PUBLIC UTILITIES COMMISSION

RE: Olinda Last Mile Underserved Broadband Project IS/MND – Responses to CDFW Comment Letter

Attachment 1 – CDFW's Vernal Pool Point Location

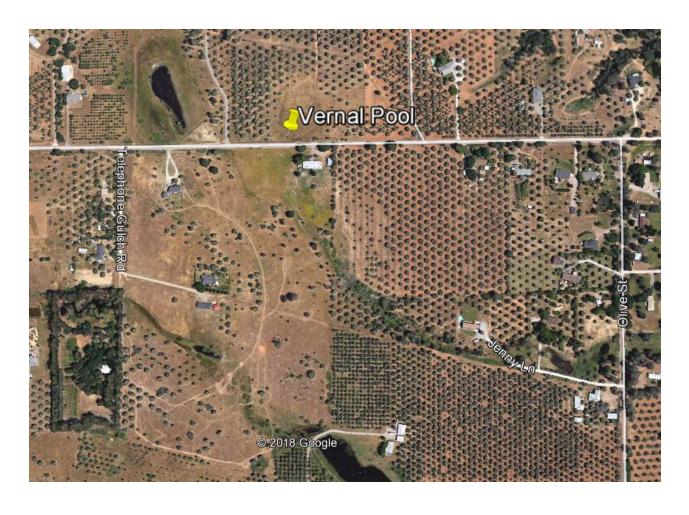
The kmz file provided by CDFW is a data point (See Attachment 1). This data point is located on Scout Avenue, between Telegraph Gulch Road and Olive Street, in the proximity of waterway WW-15 (unnamed tributary to Telephone Gulch), identified on Page 78 of Appendix D of the Draft IS/MND (Waterway Delineation Report [WDR], see Attachment 2). In addition, during review, our findings show that the vernal pool location is within 250 feet of a proposed boring pit location (see Attachment 3).

In order to comply with the mitigation requirement (APM BIO-3 brought forward as mandatory mitigation under MM GEN-1) the Applicant (TDS Telecom) is required to modify the boring pit location adjacent to WW-15 (See Attachments 2 and 3).

The Applicant is required to move the boring location identified within 250 feet from the vernal pool that was identified by CDFW since it is brought forward as mandatory mitigation under MM GEN-1.

Relocating boring pits outside of the 250-foot buffer zone shown in Attachment 3 would ensure that bore pits are located at least 250 feet away from the vernal pool, in compliance with Applicant Proposed Measure (APM) BIO-3 (brought forward as mandatory mitigation under mitigation measure (MM) GEN-1). APM BIO-3 states the following:

"Bore pits will be placed a minimum distance of 76 m (250 feet) beyond either the edge of seasonal wetlands or the maximum extent of any vegetation present along the wetlands' margins."
